DOCKET	
08-AFC-8	
DATE	MAR 11 2011
RECD.	MAR 11 2011

CEC docket # 08-AFC-8

Data Request from AIR (March 11, 2011):

Figure AIR 2-1. Number of Days Above 2008 8-Hour Ozone National Standard

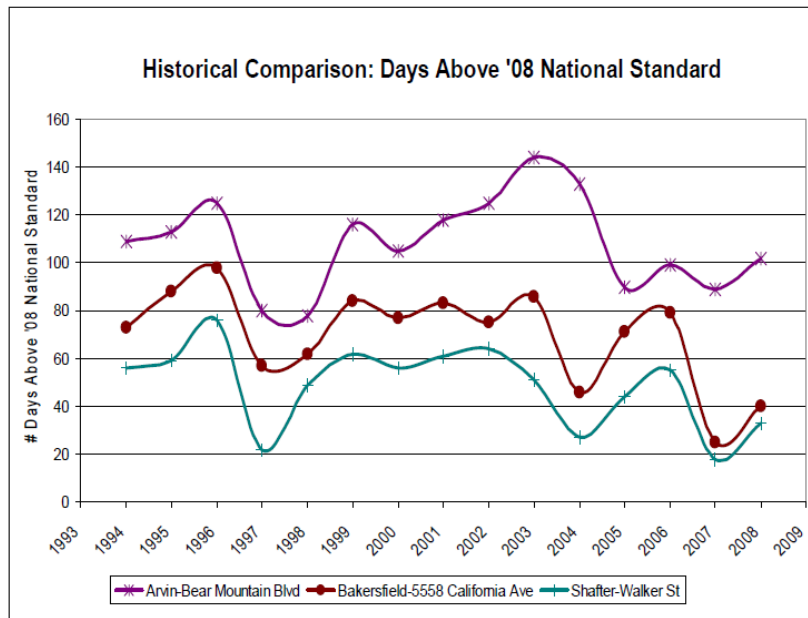
The figure below was used in AIR's earlier data request to show that Shafter has significantly cleaner air historically, in regards to ozone violations, than either Arvin or Bakersfield.

Even though Shafter is closer to the HECA site than Bakersfield or Arvin it is not the most appropriate monitoring site for the purposes of estimating local air quality around HECA. Shafter, because of its location, has exceptionally good air quality compared to other places in Kern County where there are monitors for ozone levels. Shafter also has better air quality than places to the north such as Corcoran or Fresno proving that local pollution levels in Kern County are influenced by what is relatively nearby and not so much from what drifts down the valley from 100 miles or more to the north. The reason for this better air quality in Shafter is because Shafter sits in the middle of agricultural land and in the middle of the valley floor (there are no hills or mountains nearby). It also has no big industrial sources of pollution nearby or major highways and roads with a lot of heavy truck traffic. The issue of truck traffic is important as will be explained.

A. HECA

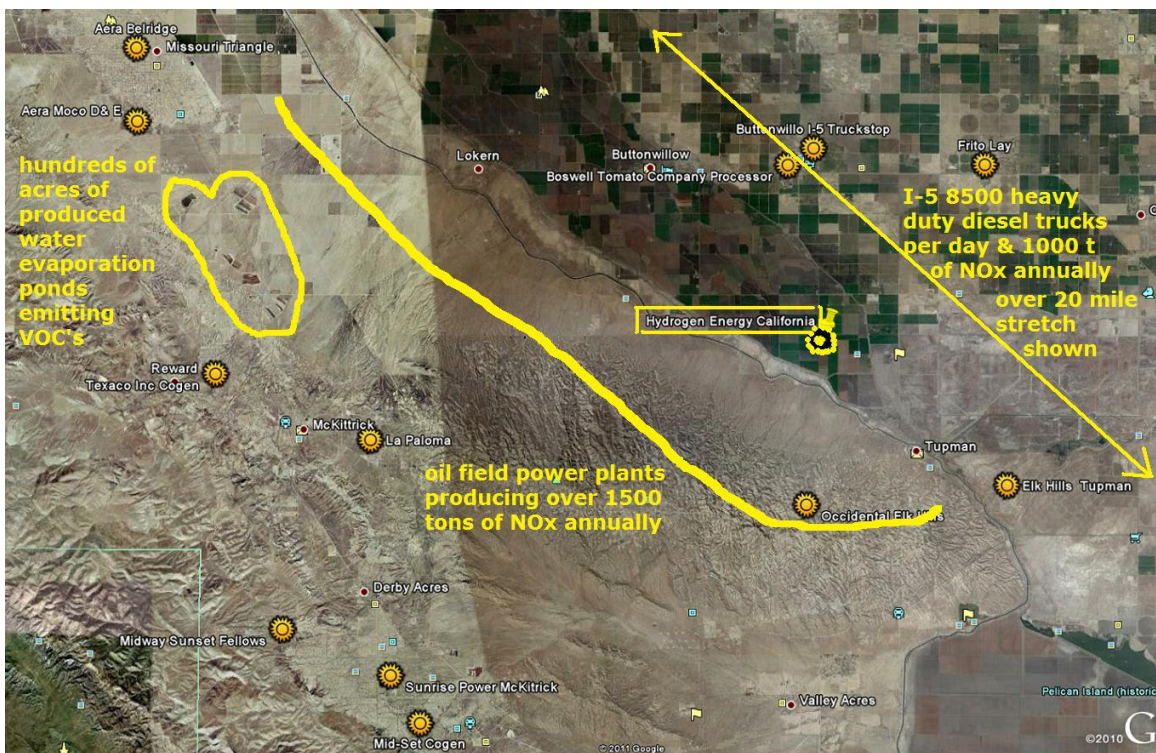
The following satellite photos, with some labels, also illustrate that Arvin should have been the monitoring site chosen for the HECA analysis. The viewer can easily see that major sources of NO_x and VOC's will strongly influence the air quality around HECA which sits up against the hills to the south and higher mountains not far to the southwest. If the applicant or the CEC needs a tour of the area to see this reality, AIR can arrange such an outing.

32,000 vehicle trips per day, in comparison. Seventh Standard and Hwy 58, near HECA, would have many thousands of daily trips as well. As Arvin shows, sources of NOx do not just cause air pollution for nearby sources. It is logical to assume that traffic near HECA is a far greater pollution factor on local areas than the traffic near Shafter.

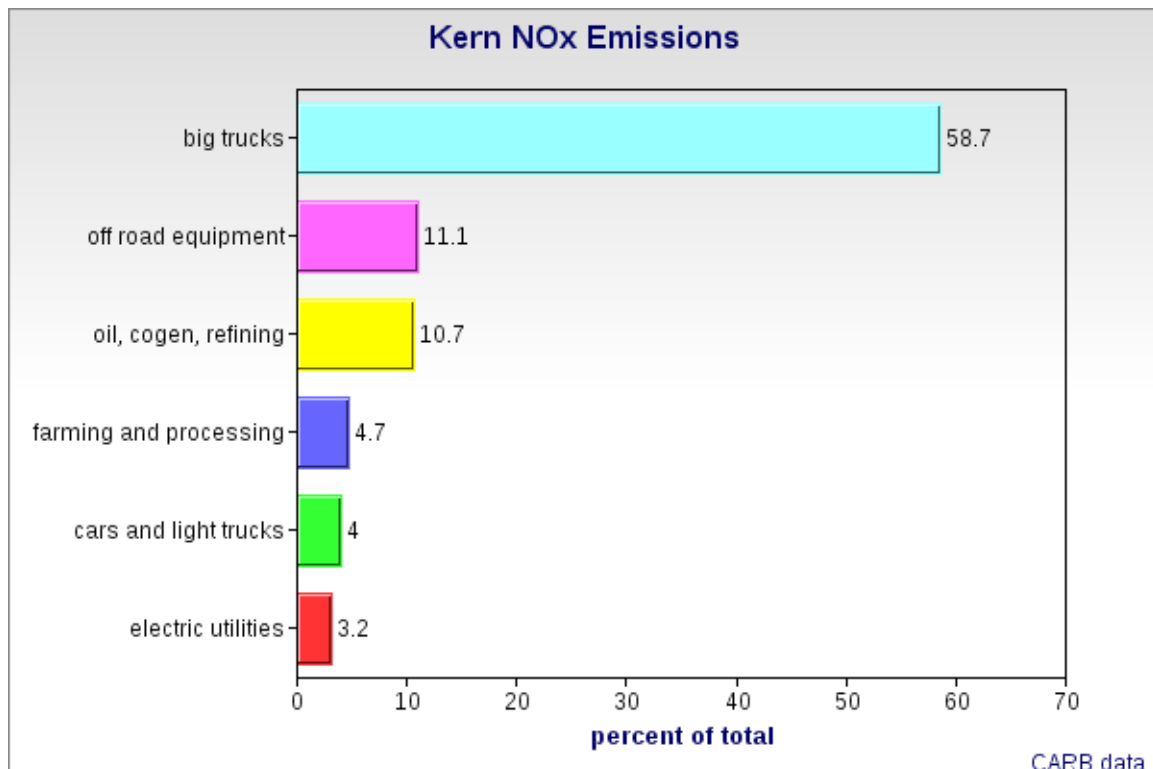
In the choosing of the location for the most appropriate monitor it is important to not assume that the 10,000 (14,000) vehicle trips through Shafter are similar in nature to the traffic and other conditions nearby HECA. For example, heavy duty truck traffic through Shafter is a much smaller percentage of total vehicle numbers when compared to the percent of heavy duty trucks on I-5 in the HECA area (10% vs. 30%). There are also 25 times more heavy duty diesel truck trips daily on nearby I-5 compared to Hwy 43 in Shafter. In the appendix following this data request are the figures showing the traffic on these two major highways of concern. I-5, near HECA, has 7,499 heavy diesel truck (5 axle) trips daily and Hwy 43, in Shafter, has 300 similar daily trips.
